# S E R V I C E N O T E

## Agilent 66312A DC Power Supply

**On faster computers, when programming over GPIB, a random error will occur.**

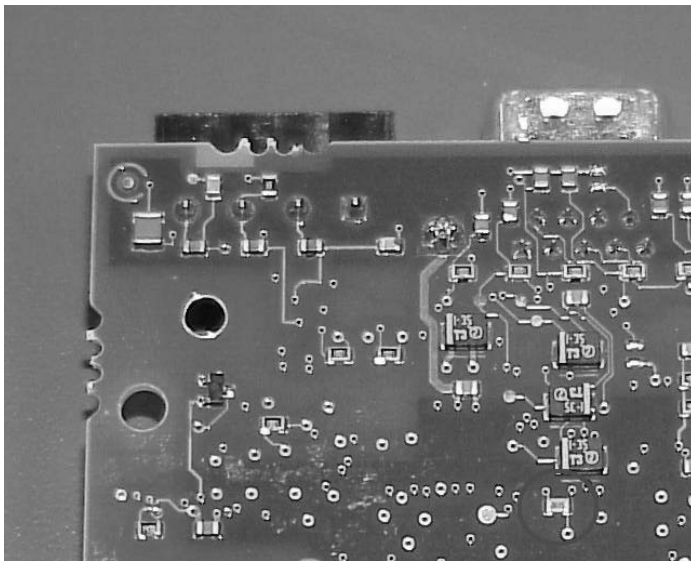
When programming a unit over GPIB, a random error -113 (“Undefined header”) will appear on the unit. This error can be read back via the front panel or over the GPIB bus.

Change resistor R1246 (see picture for location) from 511 Ohms to 100 Ohms (part number 0699-3058). This requires un-soldering and soldering a surface mount component and can be very difficult. This does not require re-calibration.

Replace the entire GPIB assembly (part number 5063-4841) with a newer one that has the 100 Ohm resistor. This will require the unit to be re-calibrated.
